SERVICE BULLETIN No. 300-2-94

Subject: Attachment of engine control bowden cables

Models affected: EA-300 EA-300/S

Figure 1 Correct alignment angles

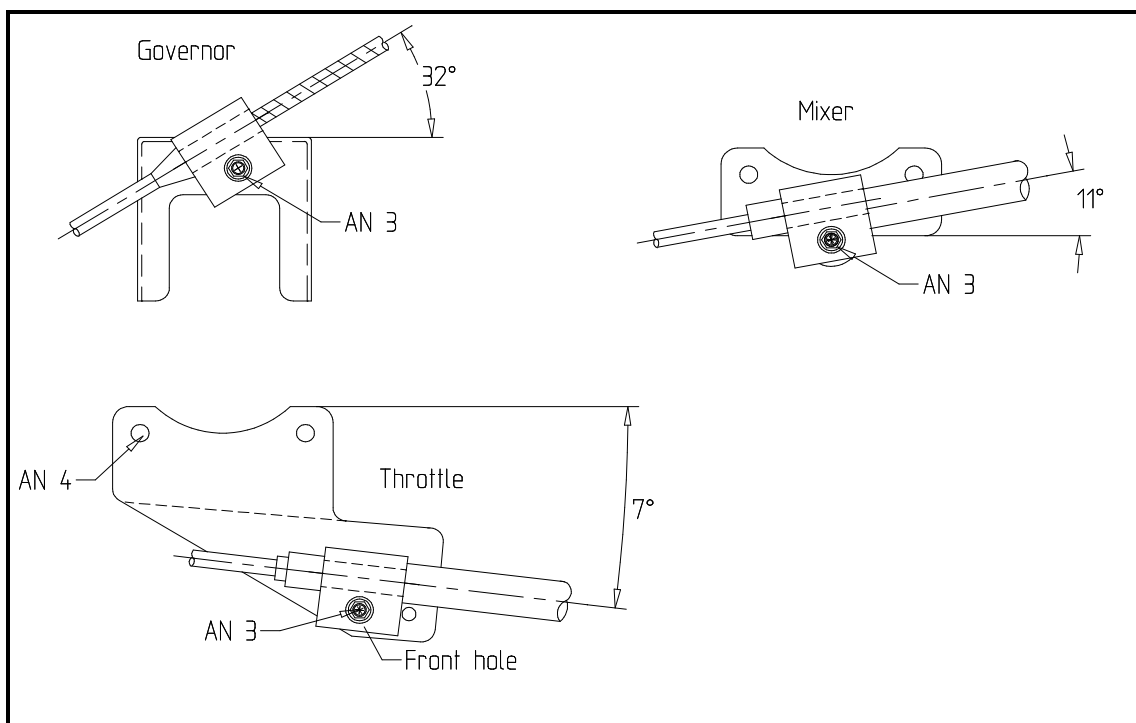
A proper function of the bowden cable depends on the angle between bowden cable clamp block and the attachment (refer to Figure 1). For this reason the respective alignment angle and the bolts torque of the AN 3-10A bolts has to be checked. The correct bolt torque value for the AN 3 bolt is 3.5 to 4.5 Nm (3-40in lbs).

Figure 2 Modified attachments

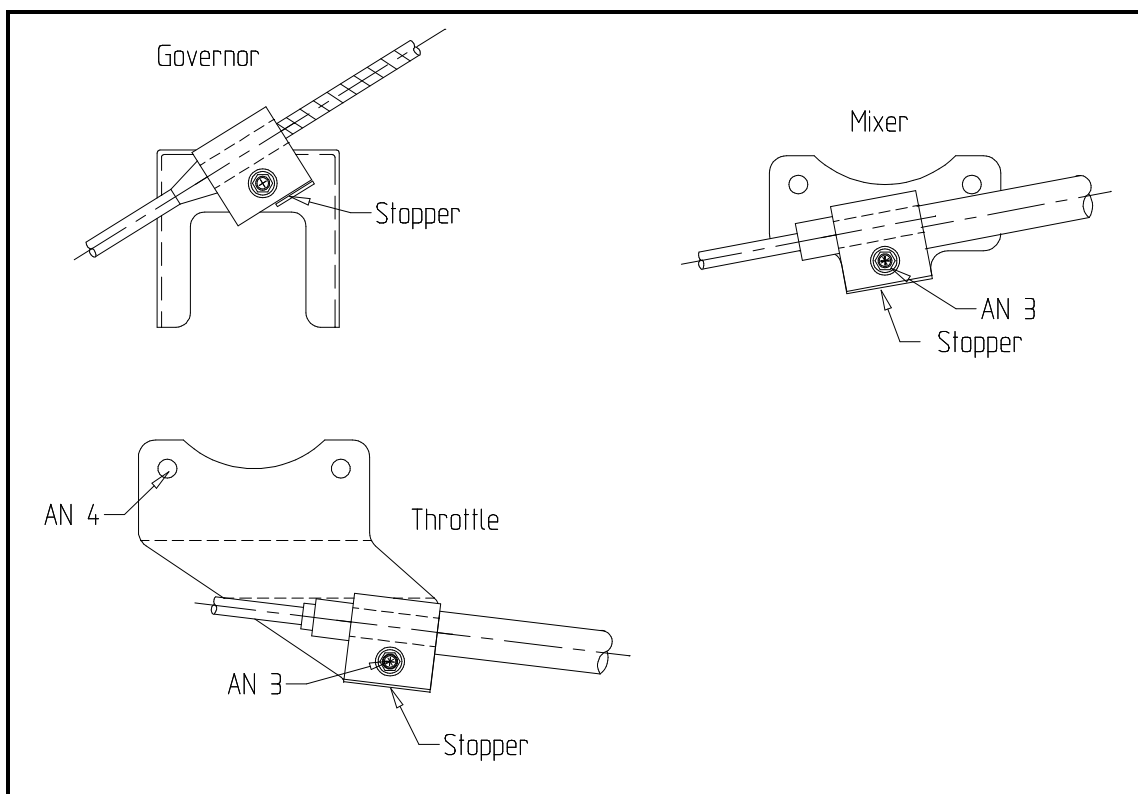
- Disassemble the existing attachments (governor bowden cable attachment PC 63301.6, mixer bowden cable attachment PC 63301.4 and throttle bowden cable attachment PC 63301.5).

- Install the new throttle and mixer bowden cable attachment with AN 4 bolts MS20074-0406 (PN\ PC-01853) and DIN 125 M6 washers (PN\ PC-00417). Use new bolts and washers if necessary. Secure the bolts with safety wire.
- The governor bowden cable attachment has to be installed with AN 3-3A (PN\ PC-00202) bolts and DIN 125 M5 washers (PN\ PC-00416). Use new bolts and washers if necessary. Always use new AN 3 stop nuts MS20365-1032A (PC -02347).
- Mount the clamp blocks on the respective attachment using AN 3-10A (PN\ PC-02252) bolts, DIN9021 M5*20 (PN\ PC-00564) and DIN 125 M5 washers (PN\ PC-00416). Use new bolts and washers if necessary. Always use new AN 3 stop nuts MS21042-3 (PN\ PC-00802). Pay attention to the stopper at the attachment sheet (Refer to Figure A2). The proper bolt torque of the AN 3-10A is 3.5 to 4.5Nm (30-40 in lbs).
